Davis-Besse Nuclear Power Station  
5501 North State Route 2  
Oak Harbor, Ohio 43449-9760

Subject: License Amendment Application to Revise Technical Specification (TS) 3/4.9.4, Refueling Operations - Containment Penetrations, TS 3/4.9.12, Refueling Operations - Storage Pool Ventilation, and Associated Bases Regarding Containment Equipment Hatch Cover Requirements (License Amendment Request 00-0005)

APPLICATION FOR AMENDMENT  
TO  
FACILITY OPERATING LICENSE NUMBER NPF-3  
DAVIS-BESSE NUCLEAR POWER STATION  
UNIT NUMBER 1

**SAFETY ASSESSMENT AND SIGNIFICANT HAZARDS CONSIDERATION  
FOR  
LICENSE AMENDMENT REQUEST NUMBER 00-0005**

DAVIS-BESSE NUCLEAR POWER STATION  
CONTAINMENT STRUCTURE EQUIPMENT HATCH DETAIL  
FIGURE 3.8-4

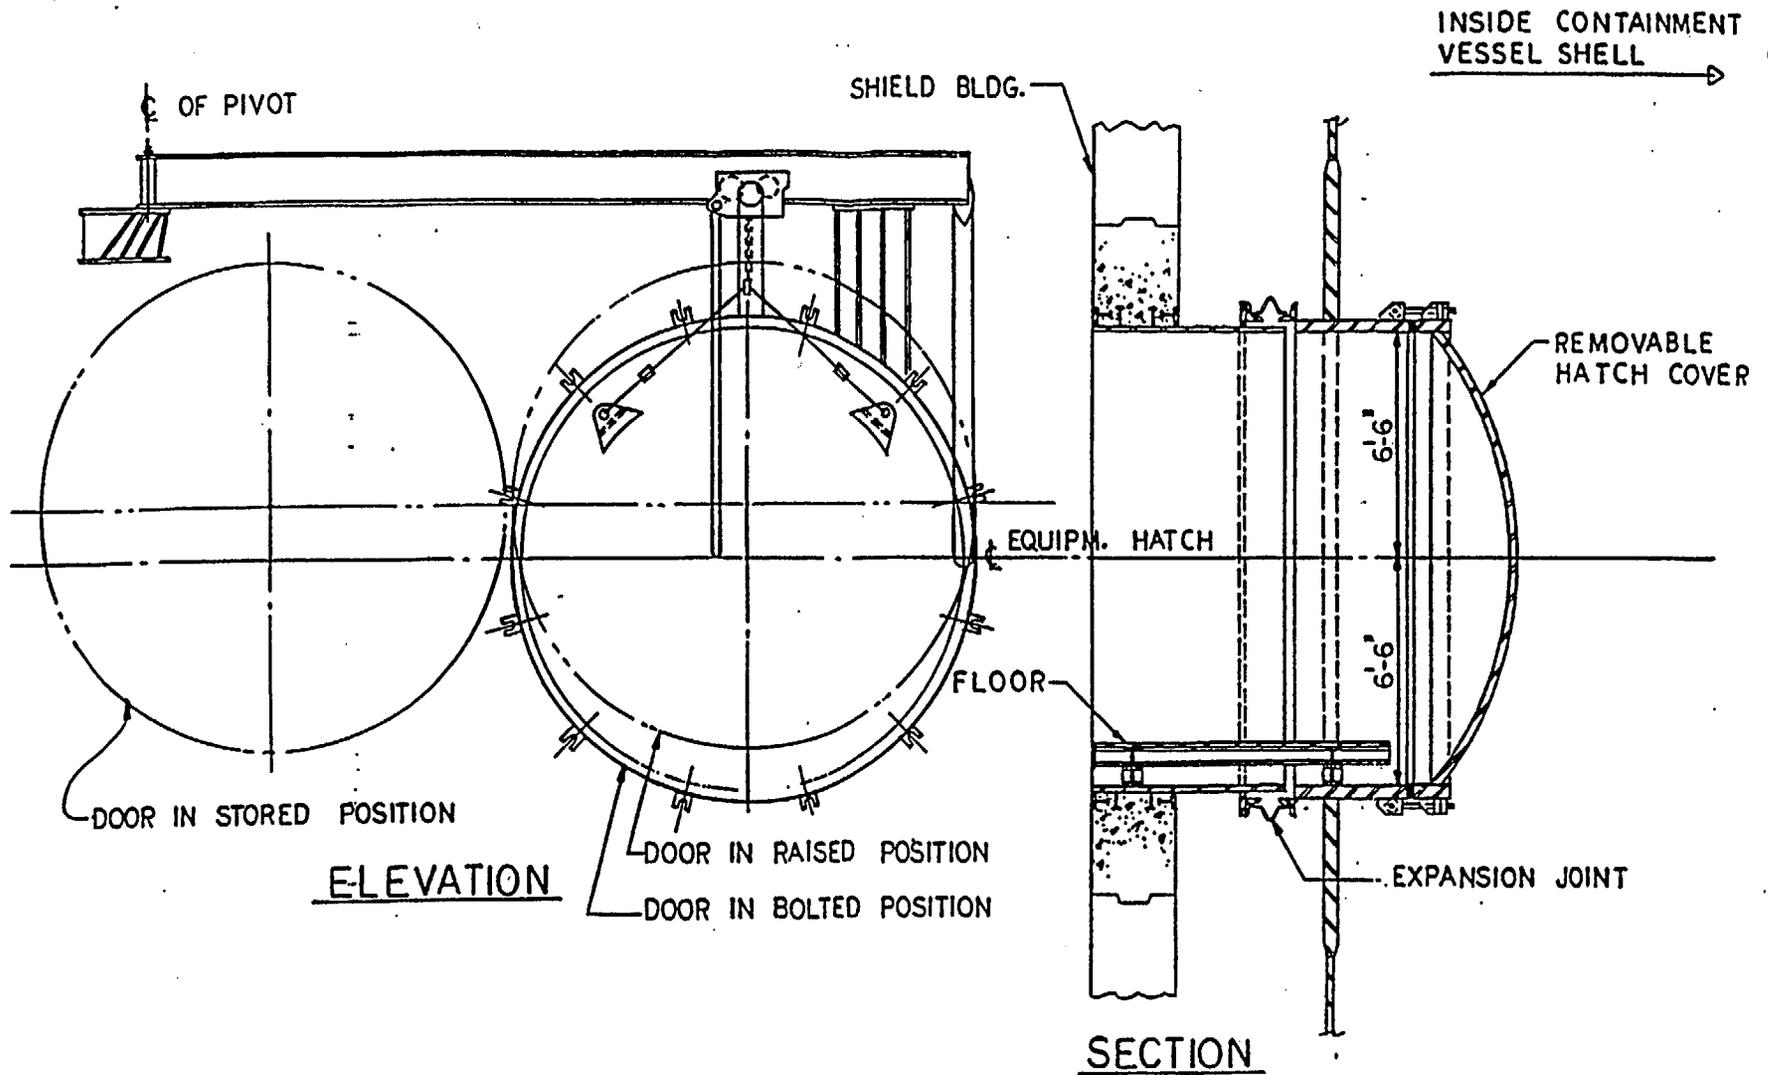
The containment equipment hatch cover (shown in attached Figure 1) is located inside containment and must be completely unbolted, raised, and moved to the side through the use of a chain hoist and monorail in order to allow access. Returning the containment equipment hatch cover to a closed position requires that the closure personnel remain inside containment, move the hatch cover along the monorail, lower it into position, and align the bolt holes. After bolting the cover into place, closure personnel then exit through the personnel air lock.

DBNPS Auxiliary Building and Shield Building (603' Elevation)

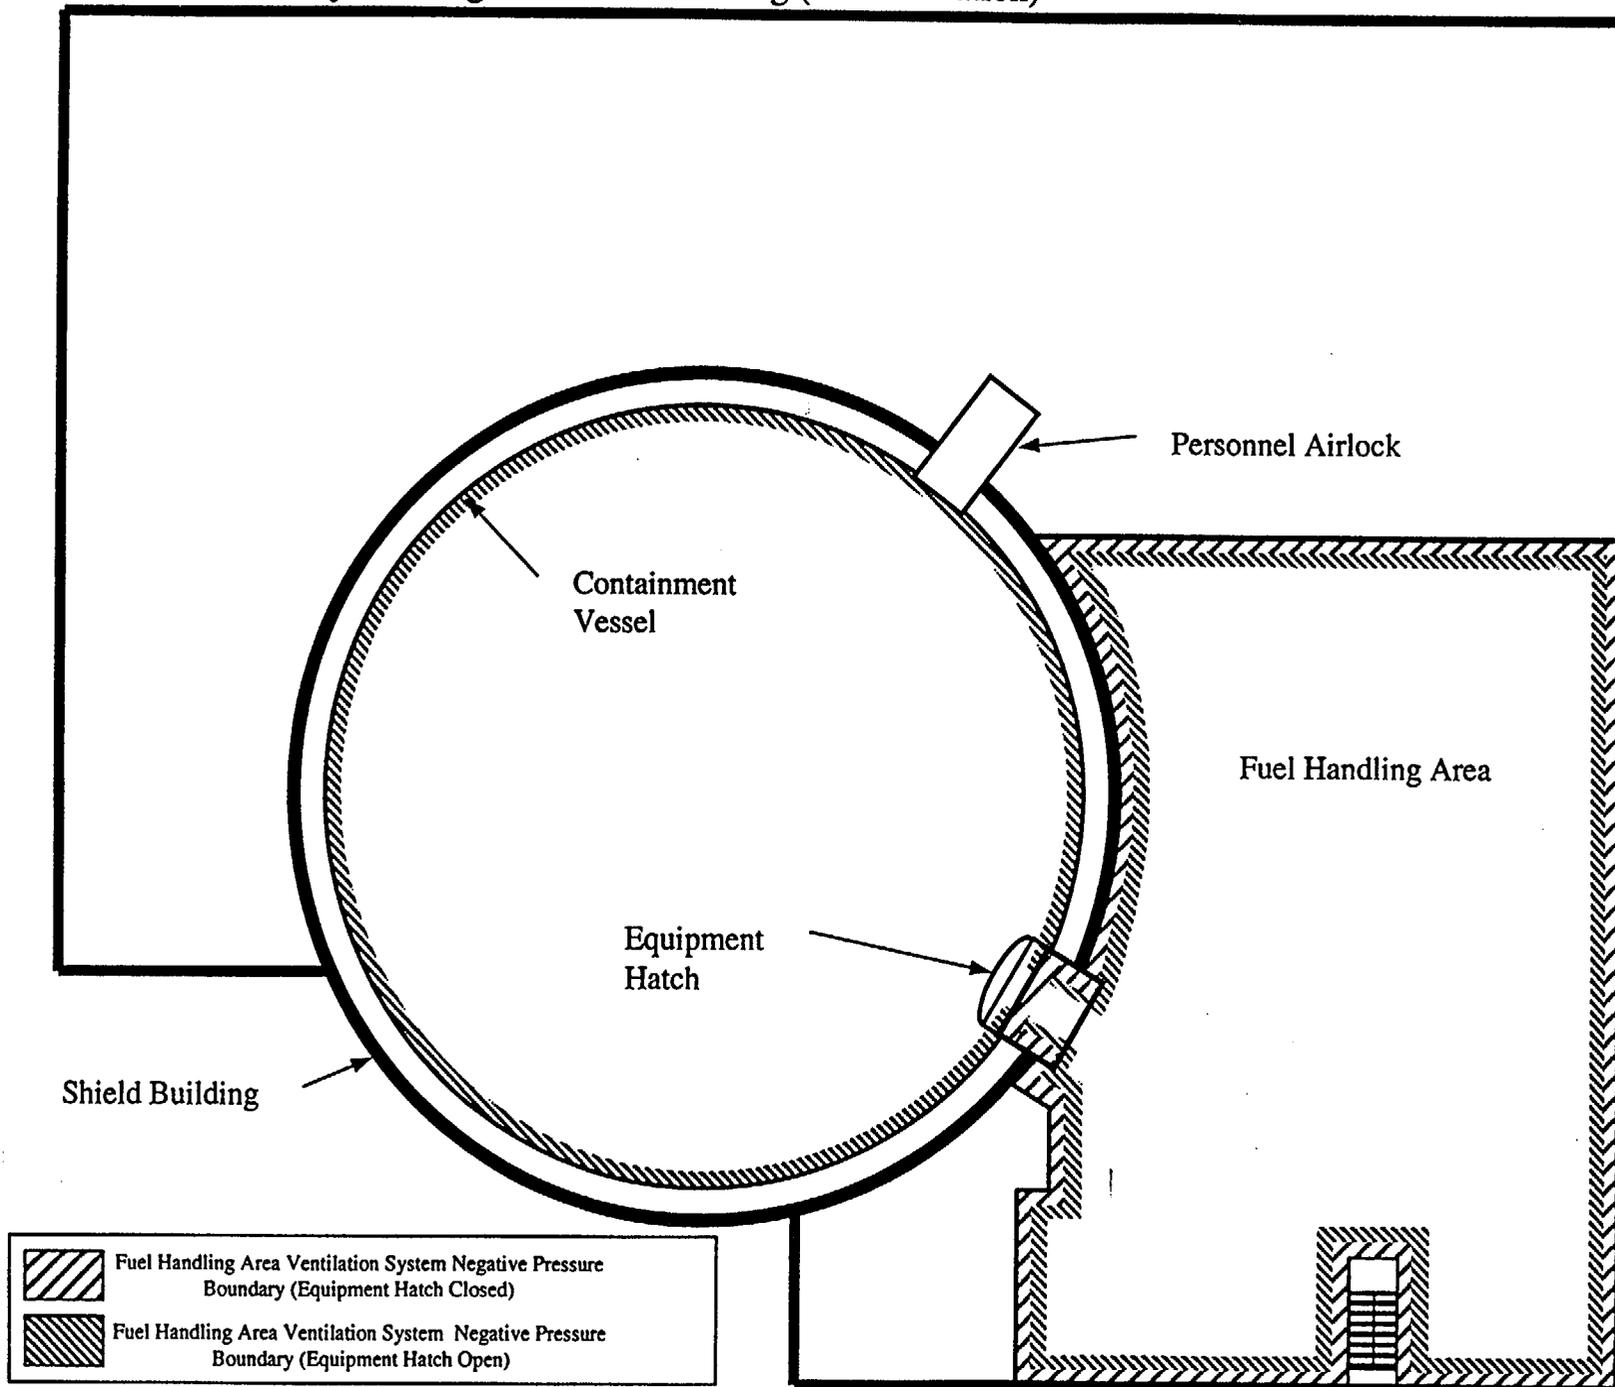
As depicted in Figure 2, the containment equipment hatch opens into the fuel handling area and not into the out-of-doors environment. This area is serviced by the Emergency Ventilation System (EVS), which can draw air from this area and filter it through high efficiency particulate air filters and charcoal adsorbers prior to discharge to the out-of-doors environment.
